REMARKS

Application No. 10/542,898
Paper Dated: September 5, 2007
Reply to Office Communication of March 6, 2007
Attorney Docket No. 0702-052257

FIG. 5

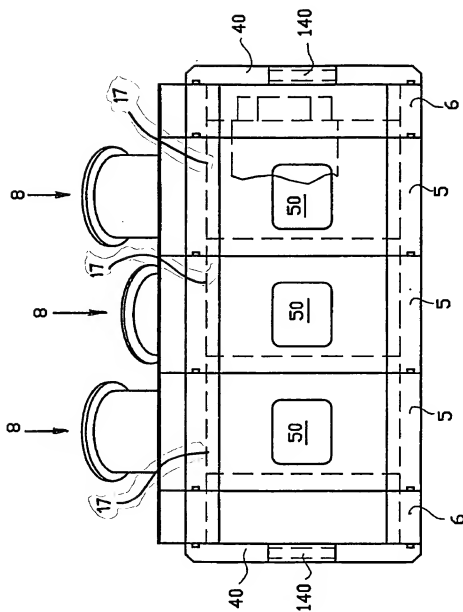
The Examiner has also objected to the drawings under 37 C.F.R. § 1.83(a) as not showing every feature of the invention specified in the claims. In particular, the Examiner notes that the "cylinder" recited in claims 28-30 is not present in the drawings. Applicant respectfully submits that the "cylinder" was and is illustrated in the drawings, but was not specifically referred to by a reference character. Therefore, reference character "17" has now been used to refer to the cylinder, and the specification has been appropriately amended to support this drawing modification. Entry of the amendments to the drawings, i.e., Figs. 5-7, and the specification is respectfully requested. These modifications address and overcome the Examiner's objection to the drawings in this regard.

Please replace the originally-filed sheets of drawings containing Figs. 5-7 with the Replacement Sheets of Figs. 5-7. These replacement figures identify the cylinder 17 as described in the paragraph added in the foregoing "Amendments to the Specification" section above. No new matter has been added.
